## STAFF REPORT

### CITY OF COLUMBUS PLAN COMMISSION (July 13, 2016 Meeting)

**Docket No. / Project Title:** PP-16-02 (Wildflower Ridge Major Subdivision Preliminary Plat Replat)  
**Staff:** Allie Keen  
**Applicant:** Joli Development  
**Property Size:** 23.26 Acres  
**Current Zoning:** RS3 (Residential: Single-Family 3)  
**Location:** North end of Daylily and Periwinkle Drives, in the City of Columbus

PRELIMINARY PLAT REPLAT  
 (LOT LAYOUT)

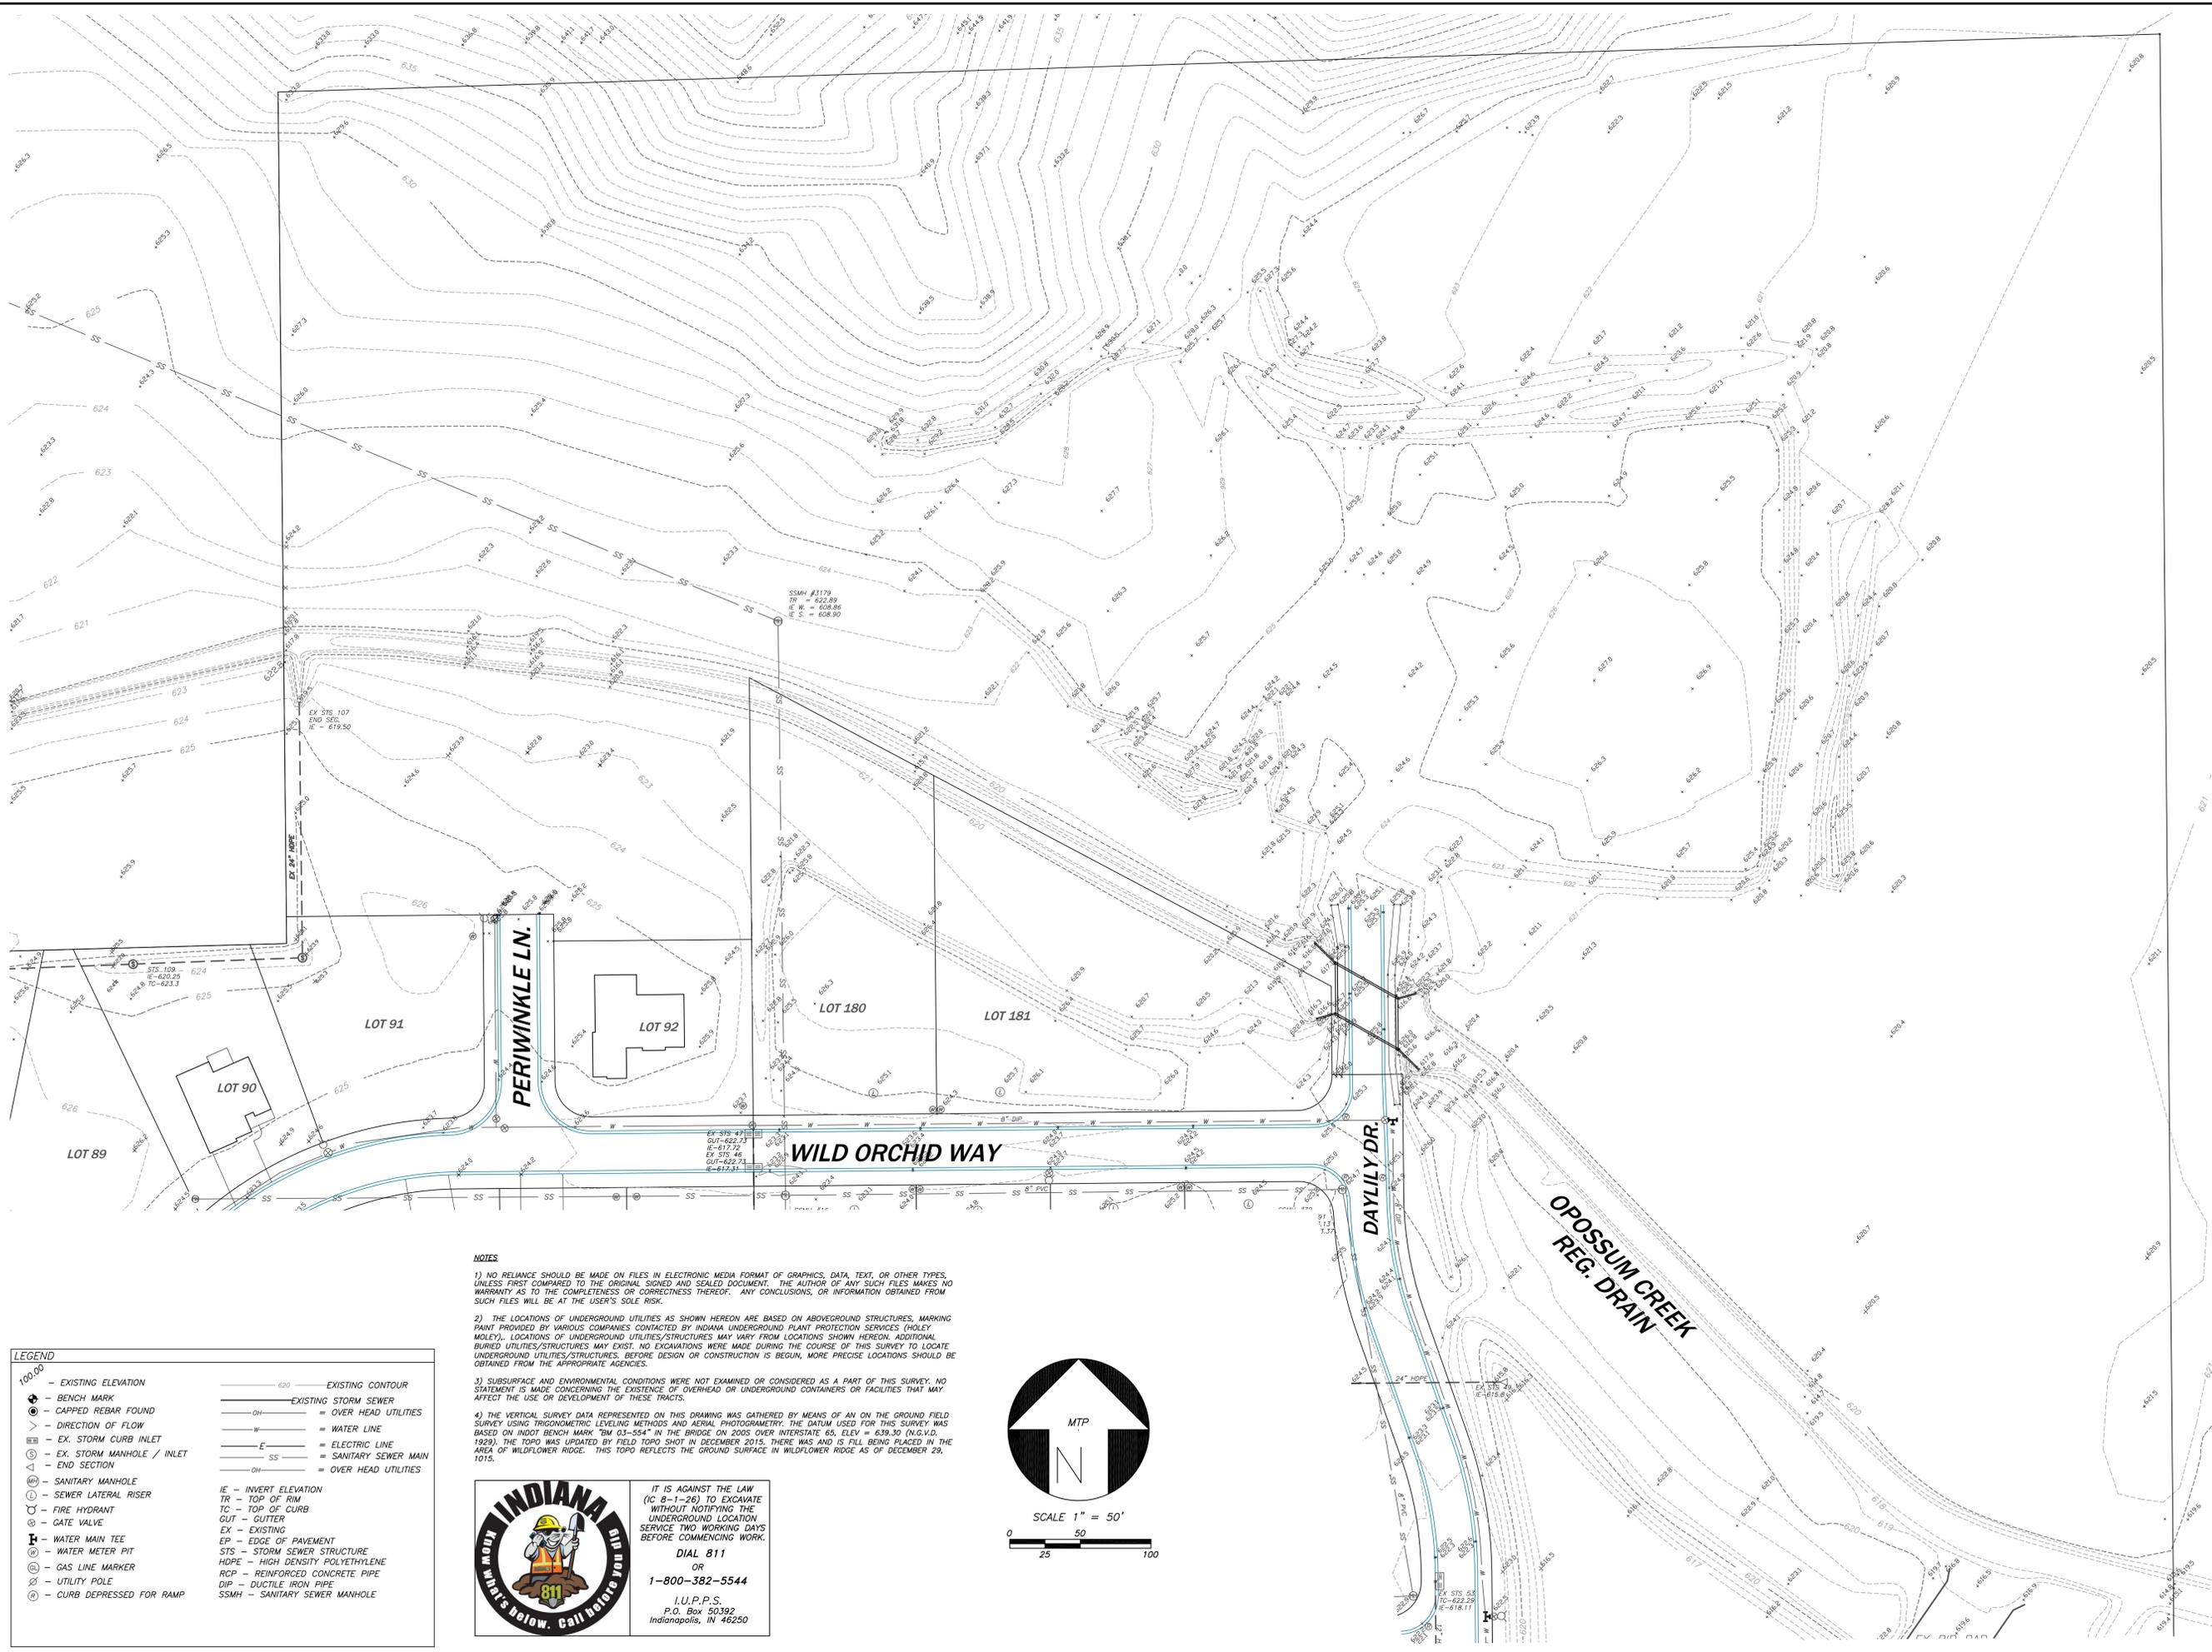
<b>Drainage Board:</b>	<p>An access easement over Block D was originally going to be provided with the recording of the final plat for Wildflower Ridge. Now that Block D is not included the Drainage Board will need an easement. This can be done through either an administrative Subdivision or through a recorded Surveyor's Correction on the original plat for Wildflower Commons.</p> <p>The Drainage Board supports the modification request because the trees will be kept out of the Opossum Creek regulated drain right-of-way.</p>
------------------------	---

2. Common Area 1 originally was 6.09 acres in size and was the location of an existing detention pond. The detention pond was originally a part of the Wildflower Commons preliminary plat, but was then made a part of the Wildflower Ridge preliminary plat. At this time, the applicant is proposing to reduce the size of Common Area 1 to 2.59 acres and exclude the existing detention pond from being a part of Wildflower Ridge; therefore the existing pond will remain a part of Wildflower Commons. The applicants are proposing to use Common Area 1 as the location of a different detention pond.

Approval of the revised preliminary plat including the street tree spacing modification with the following commitment: An easement shall be provided on Block D for the Bartholomew County Drainage Board to provide access to the Opossum Creek regulated drain.

PRELIMINARY PLAT REPLAT  
STREET TREE PLANTING PLAN

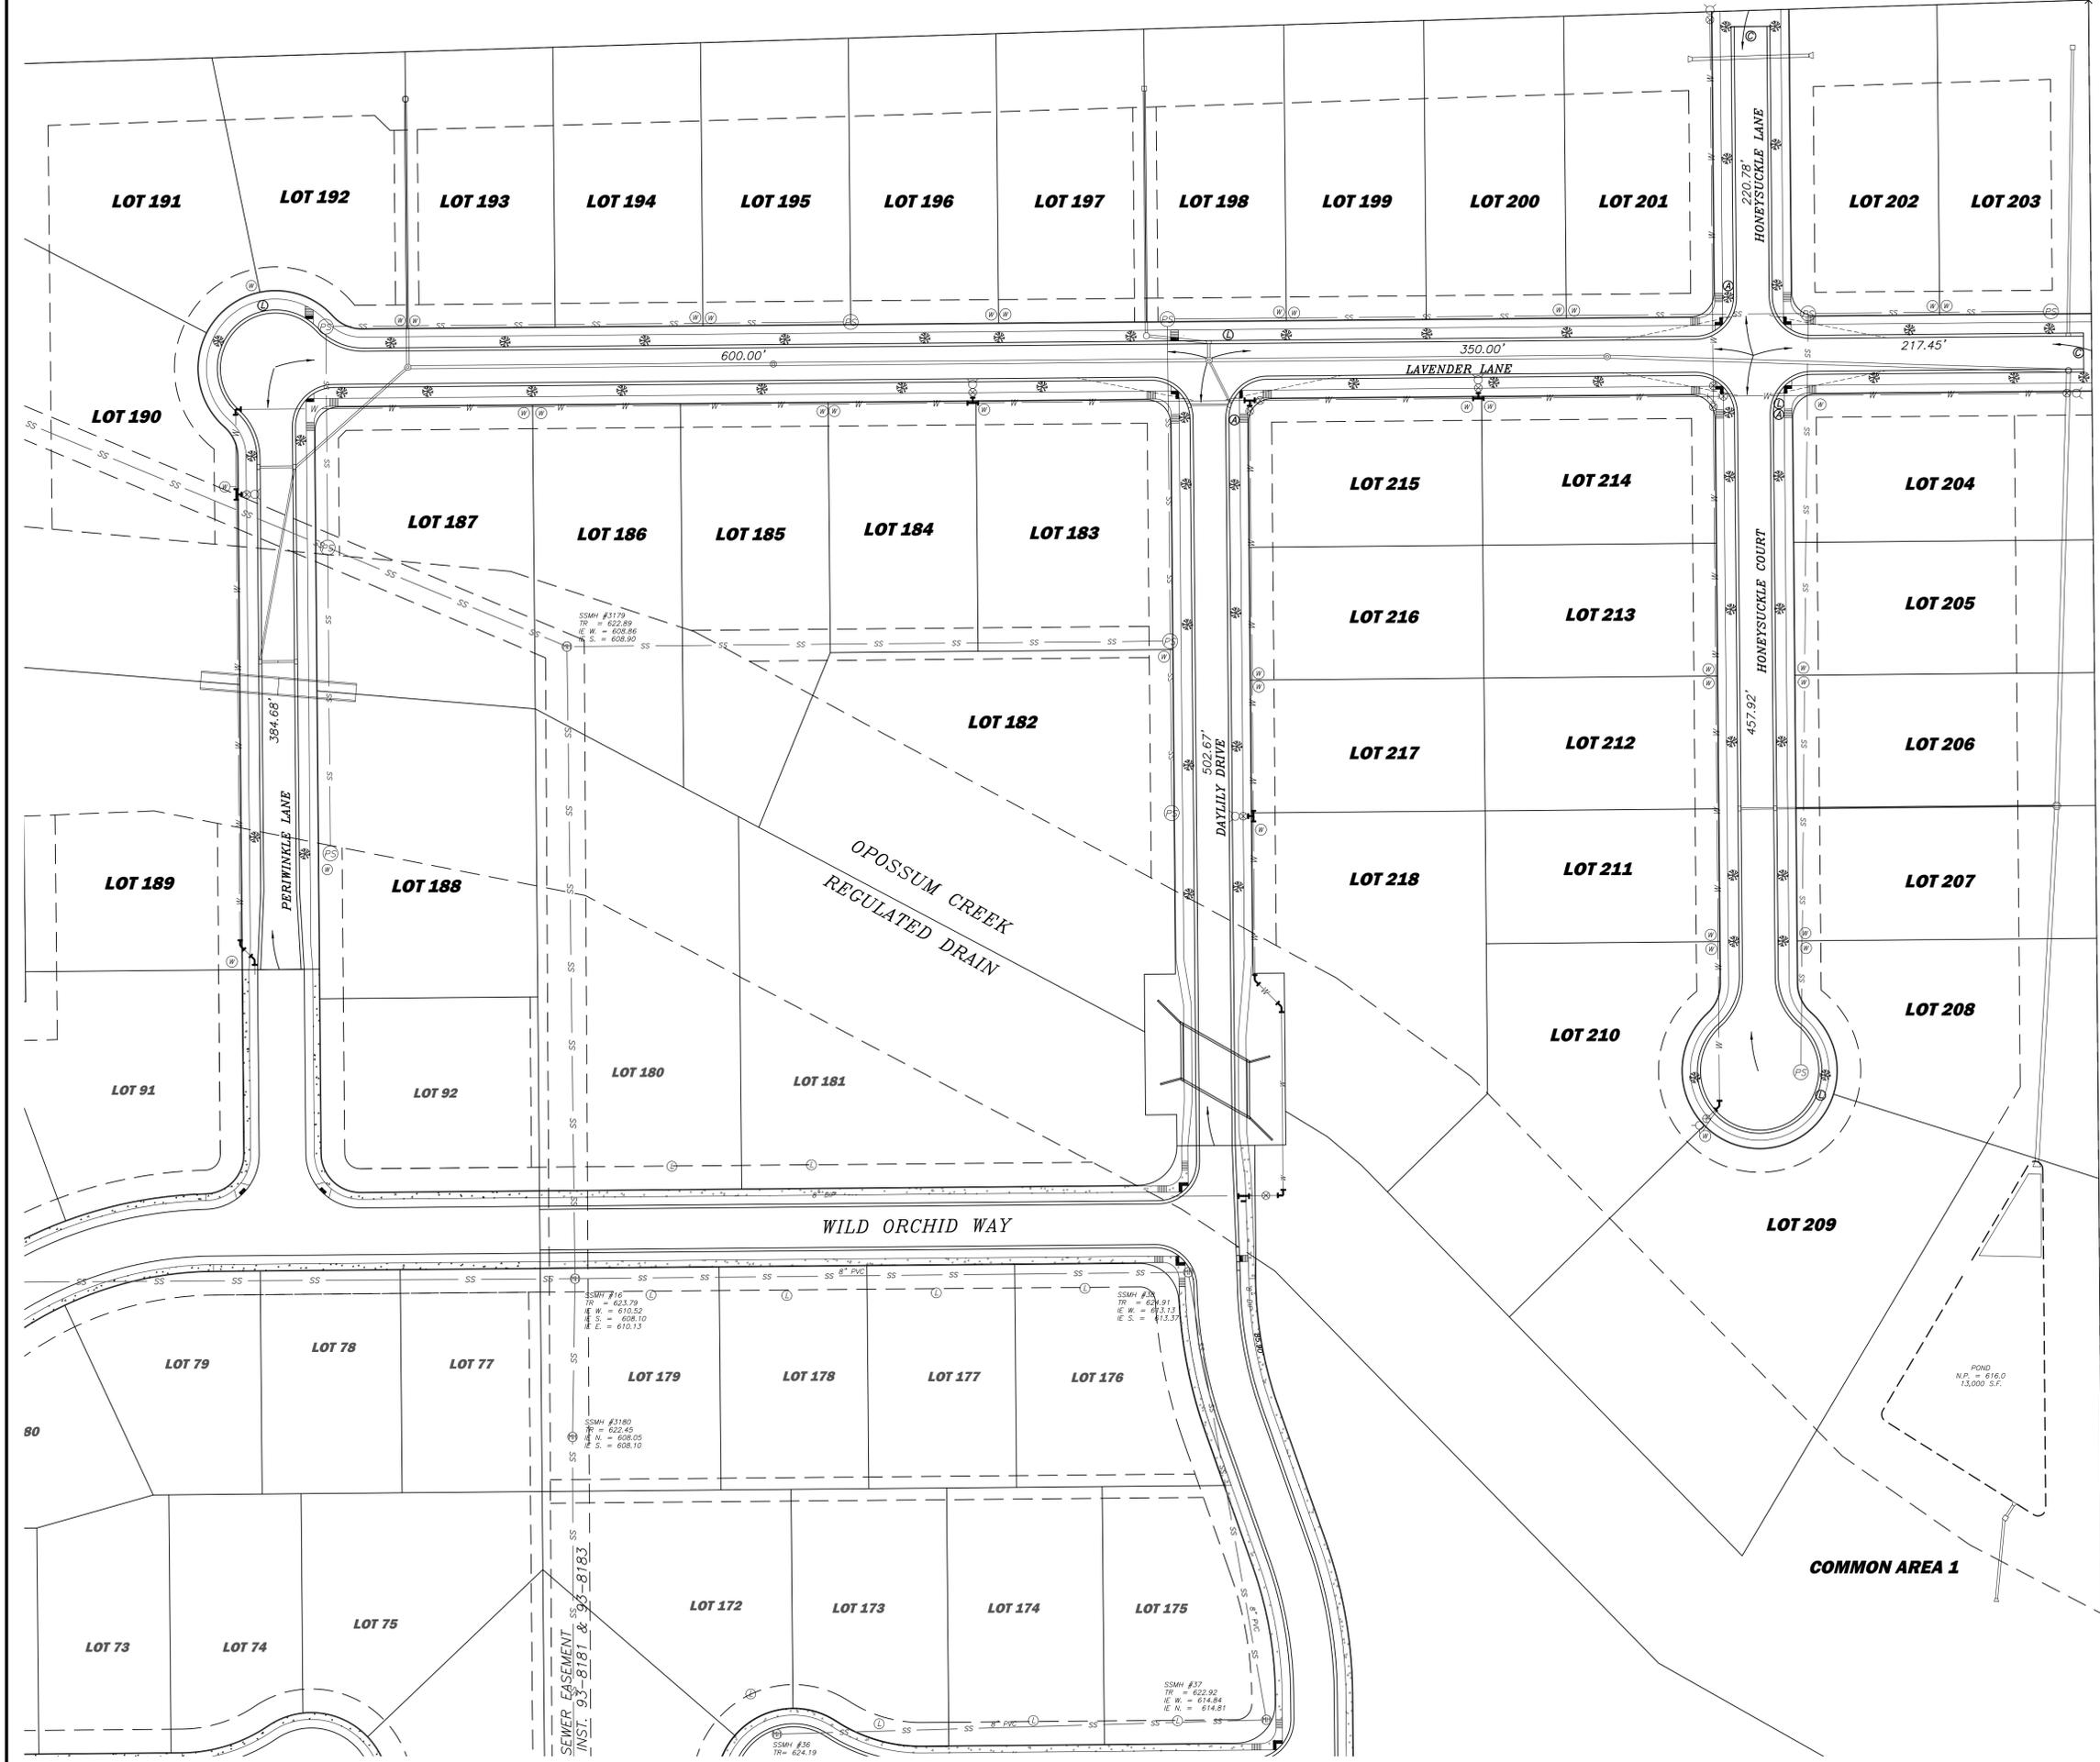
3. Subdivision Control Ordinance Section 16.24.070(Table 16.24-8) requires street trees to have a minimum spacing of 30 feet and a maximum spacing of 90 feet between each tree. The Opossum Creek regulated drain crosses through the subdivision site at both Periwinkle Drive and Daylily Drive. The Bartholomew County Drainage Board has indicated that there shall be no trees located within the regulated drain right-of-way, which is approximately 210 feet wide along Periwinkle Drive and 150 feet wide along Daylily Drive. In order to keep the street trees out of the regulated drain right-of-way, the applicant is requesting a modification to allow the street trees at these locations be permitted to exceed the 90 foot maximum separation requirement, with the proposed maximum separation being approximately 265 feet.

4. Approximately 8 street trees would be required to be planted along the frontages of Periwinkle and Daylily Drives where the regulated drain right-of-way is located. The applicant has indicated that they

have relocated 4 trees elsewhere in the subdivision but are seeking the modification to omit the remaining 4 trees.

1) Section 16, Table 16.24-8. This table states that the maximum length of separation between street trees is 90 feet. Opossum Creek Regulated Drain crosses Periwinkle Lane, and Daylily Drive within this subdivision. Indiana Code 36-9-27-33(d) prevents trees from being placed within a regulated drain right-of-way. Due to the width of the regulated drain right of way, and other utility conflicts this separation requirement cannot be met. A modification is being requested to allow the maximum separation between trees to be increased to 265 feet along Daylily Drive and Periwinkle Lane. The total frontage width of regulated drain right of way is approximately 700 feet. This essentially reduces the useable street frontage for placing trees, which will result in the reduction of the overall number of trees required.

- 1) TREES SHOULD BE PLACED IN THE TREE LAWN AS SHOWN HEREON AND AS CLOSELY AS POSSIBLE IN ACCORDANCE WITH THE REQUIREMENTS FOR STREET TREES AS SPECIFIED IN THE CITY SUBDIVISION CONTROL ORDINANCE SECTION 16.24.070 (D)
- 2) TREE SPECIES SHALL BE "LITTLE LEAF LINDEN" (LILIA CORDATA) OR AN EQUIVALENT TREE FROM GROUP 1 IN TABLE 16.24-9 IN THE CITY SUBDIVISION CONTROL ORDINANCE. TREES SHALL BE A MINIMUM OF 2.5 INCHES IN DIAMETER AT TIME OF PLANTING.
- 3) NUMBER OF TREES  
REQUIRED: FRONTAGE = 5467' / 90 = 61 TREES  
PROVIDED: 58 TREES
- 4) A MODIFICATION TO THE CITY SUBDIVISION CONTROL ORDINANCE WAS APPROVED TO ALLOW THE MAXIMUM SEPARATION OF TREES TO BE 265' ALONG PERIWINKLE AND DAYLILY.
